Service Bulletin

Bulletin No.: PIT6017B

PRELIMINARY INFORMATION

Subject: Converting To Fleet Key Option RPO 6E2 or 6E8

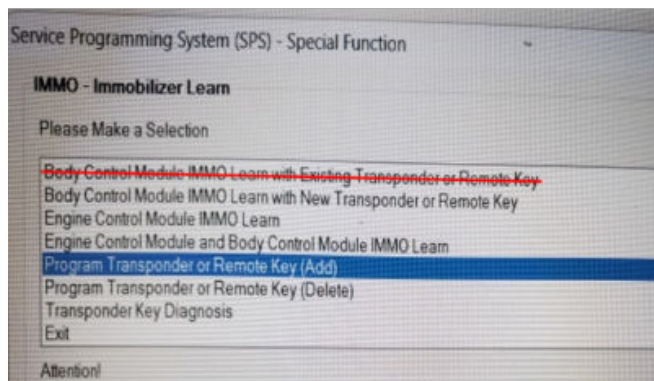
All the lock cylinders will need to be recoded to match the 6E2 or 6E8 code.
